3230 16TH AVENUE WEST

DESIGN REVIEW BOARD MEETING - 10.28.15

DPD #3019398

Interbay Apartments - Response to EDG Guidelines

APPROVED EDG MASSING

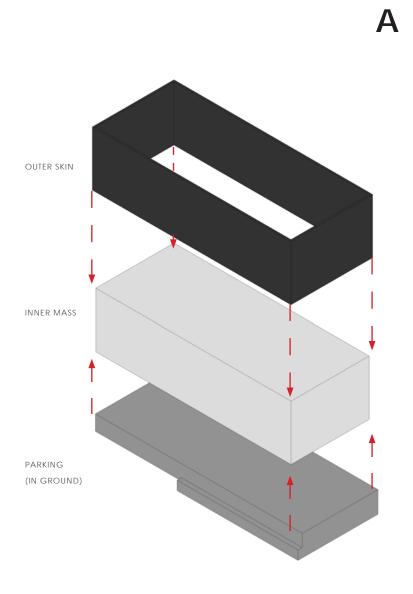
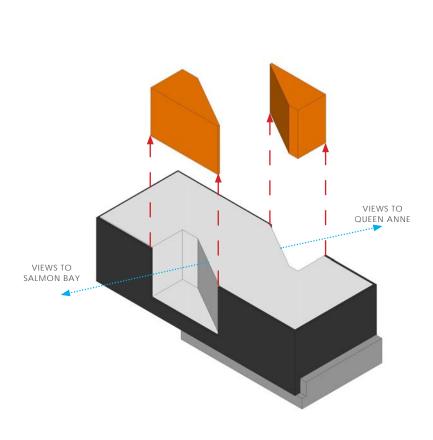
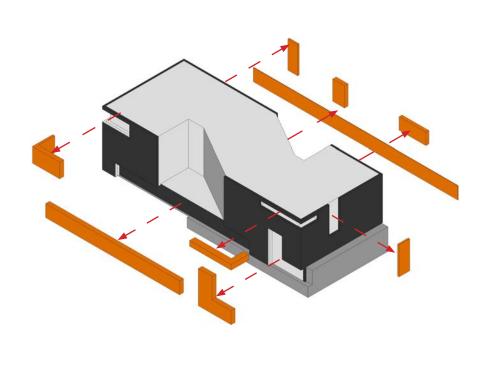
- 1 a) Noting that the facades are 300 feet long, the Board stated that massing is still a concern and stressed the importance of using secondary architectural elements and detailing to break down the massing. (Guidelines DC2-A2, DC2-B, DC2-D2)
- 1 b) Since this site visible from many areas in the city, the Board expressed interest in seeing roofscape design at the next meeting. (Guideline DC2-B1)

The dynamic form is influenced by creating directional views and reducing the scale of the building overall. A podium that includes ground level residential units at 16th Avenue West helps promote a community presence.

Introduction of dual-skin design to reduce scale of building per board direction. Exploration of roof terrace options and townhouse bookends. Vehicular access proposed from both 16th Ave W and alley.

Refined color palette and articulation of dual-skin design. An accent material is a gasket that provides clear distinction between inner and outer materials.

TOWNHOUSE DETAILING

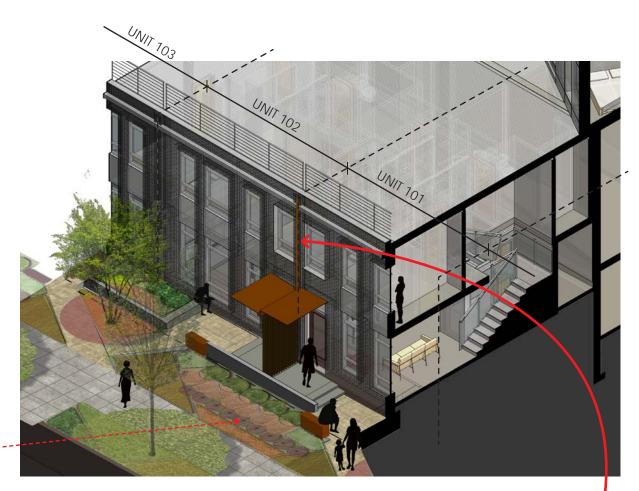
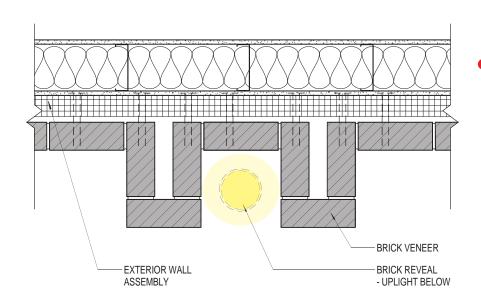
- 2 a) The Board would like to see the design of the townhouses develop with fine grain detailing. Consider ways to break up this long linear element by defining the individual unit. (Guidelines PL3-A3, PL3-A4, PL3-B2, DC2-A2)
- 2 b) The Board directed the applicant to study the termination of the units at the northwest corner. Provide security and privacy for these residential units; consider the use of a buffer between the development and the neighboring property. (Guideline PL3-B1)
- 2 c) The Board recognized that the alley/15 Ave W exposure is a very visible façade, and indicated initial support for the rich vocabulary of screening elements proposed. (Guidelines DC1-C2, DC2-B2)

The ensemble of elements at the townhouse entries include planters, weathering steel canopies, lighting and planting.

Residential edges have defensible space that helps to provide security and privacy for both pedestrians and residents. The semi-private landscape is also articulated to highlight individual units.

Folded steel canopy, screen wall at unit entries, defensible space

LOBBY FACADE DETAILING

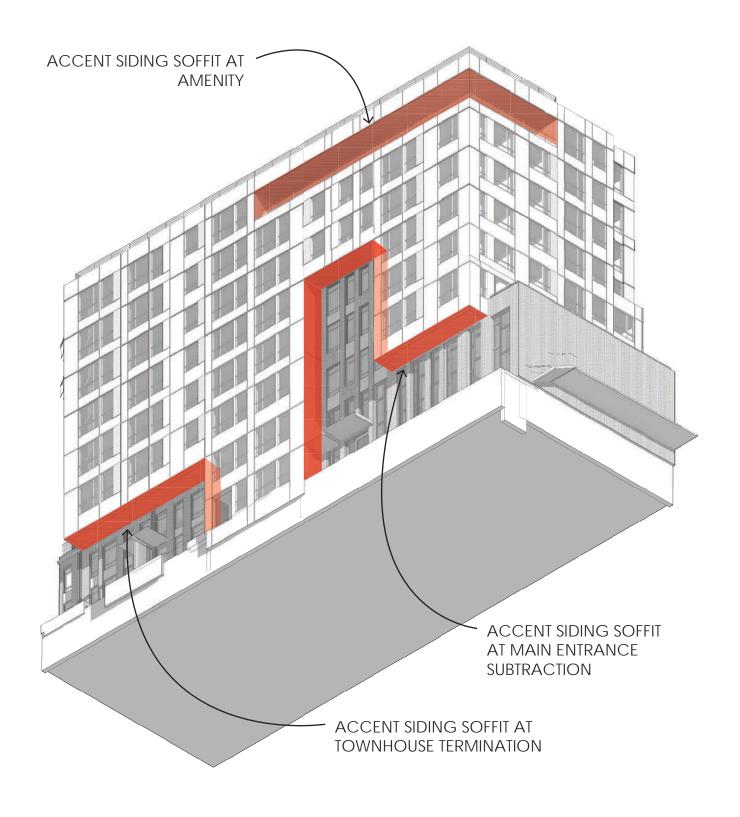
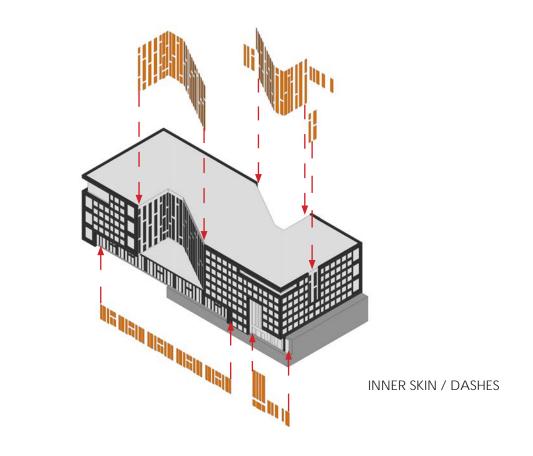
- 3 a) In developing the lobby design, the Board suggested relating the façade composition of the lobby to the massing above and perhaps the terrace plane change at the roof. (Guidelines PL2-B3, PL2-D1, PL3-A2, PL3-A4, DC2-B1)
- 3 b) The Board commended the location of bike parking near the lobby and suggested this area be expanded to include bike parking for the entire building. (Guideline PL4-B)

The main entrance is located at the corner to offer convenient access to the retailers located on Dravus. The storefront is tall and open to provide a welcoming experience.

The entry is clear to make wayfinding easy. The landscape/hardscape design also contributes to creating an architectural character in an evolving neighborhood.

When the interior "skin" is revealed an accent siding soffit is used to suggest the mass of the subtraction. Its incorporation at the main entrance ties the building together as a whole.
